Product Change Notification / RMES-19ZBNI141

CCB 4685 Initial Notice: Qualification of Ag on lead (Inner Lead Plating) material for selected SST26WF080B and SST26WF040B device families available in 8L UDFN (2x3x0.55mm) package.

PCN #: RMES-19ZBNI141

Pre and Post Change Summary

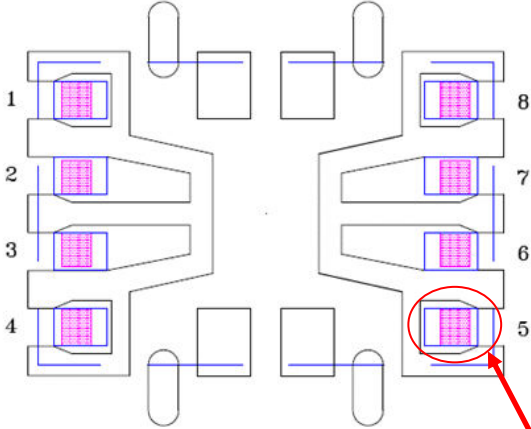
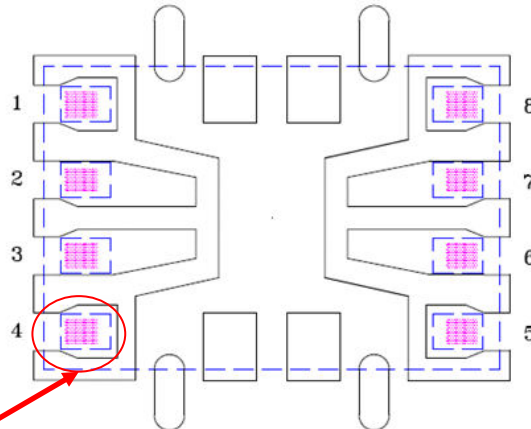
PRE CHANGE	POST CHANGE	REMARKS
LF package/type	8L UDFN 2x3x0.55mm	8L UDFN 2x3x0.55mm	Same
Inner Lead Plating (Bond Finger)	NiPdAu (Pd Custom Plating)	Ag (Ag on lead only)	Different
Lead Finish Plating	Matte Tin	Matte Tin	Same
LF Material	EFTEC-64T	EFTEC-64T	Same
LF Drawing			Different

Inner Lead Plating
(Bond Finger)
